Docket # 930-450536
 Control # 2583
 Date 3-25-83
 of Documents
 REGULATORY DOCKET FILE

3	SI	INCORPORATED FOR E-2084	
2	SI	REMOVED HOLD CIRCLES AND REMOVED EL AND COL.	
1	SI	CHANGED MCC CONT PWR FUSES AND MINOR CHANGES.	
REV	NO	DATE	DESCRIPTION
DESIGN	J. W. Hines		
CHKD	J. E. Hines		
SUPV	J. E. Hines		
SCALE:		EXCEPT AS NOTED	
GENERAL UNITS 1&2			
SYSTEM SCHEMATIC			
AUX BLDG COMMON AREA			
ENVIRONMENTAL CONT SYS			
REVIEWED	RC(CIVIL) - N/A	RE(ELEC) - N/A	RM(MECH) - N/A
SUBMITTED	RECOMMENDED	APPROVED	Q
INSPECTED AND APPROVED FOR ISSUE			
KNOXVILLE	4-23-7	56W0740-VC-04	R3
SECOND DRAWING AS CONSTRUCTED

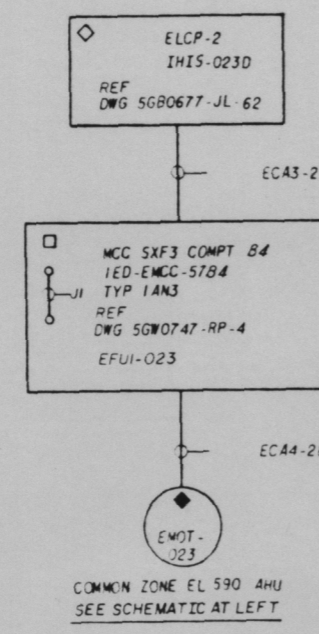
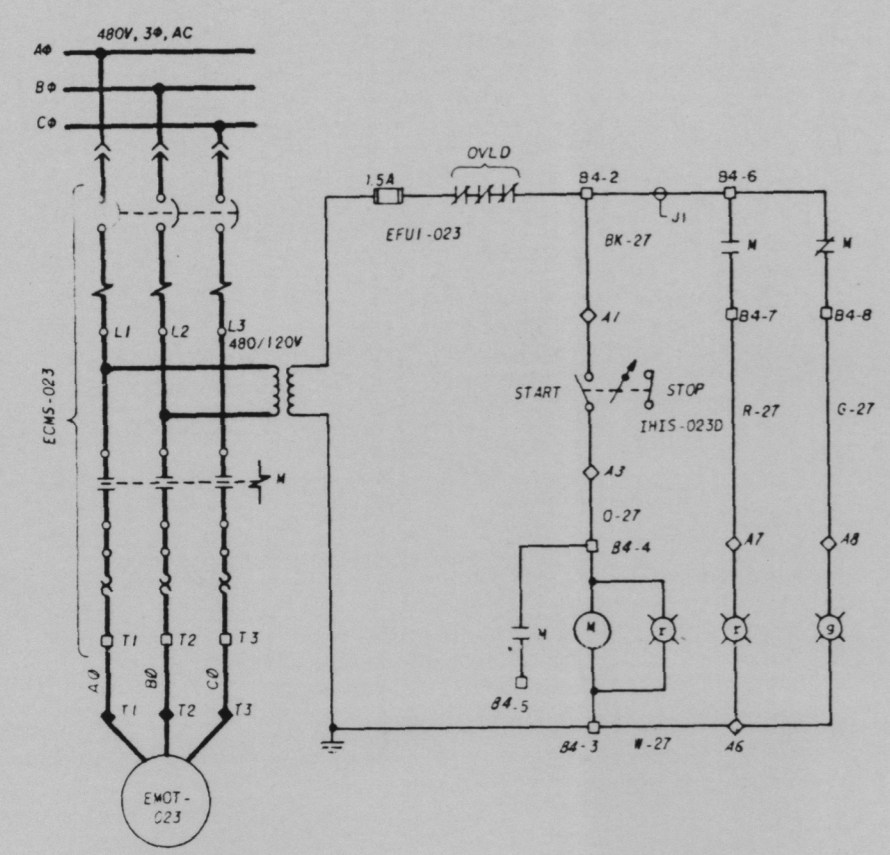
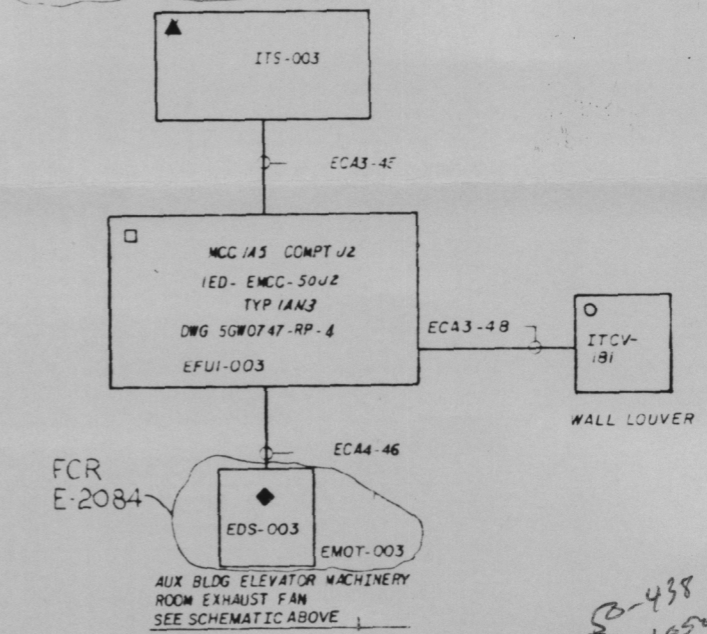
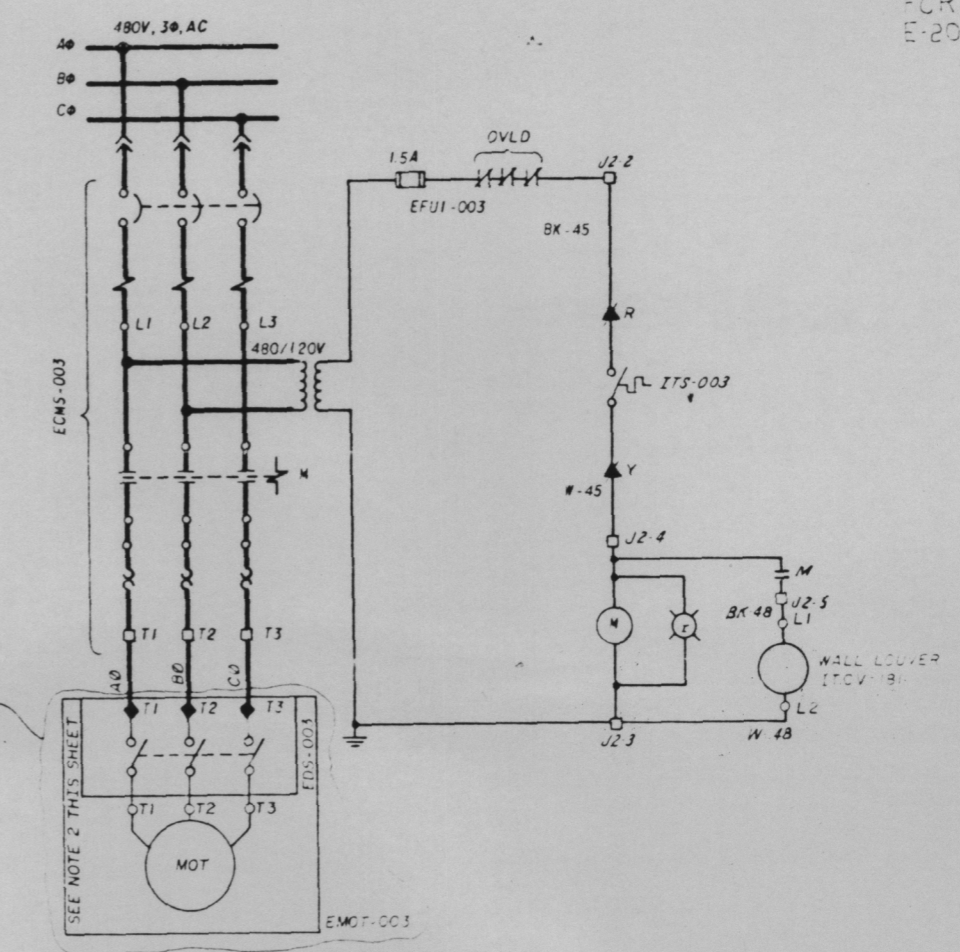
FCR E-2084
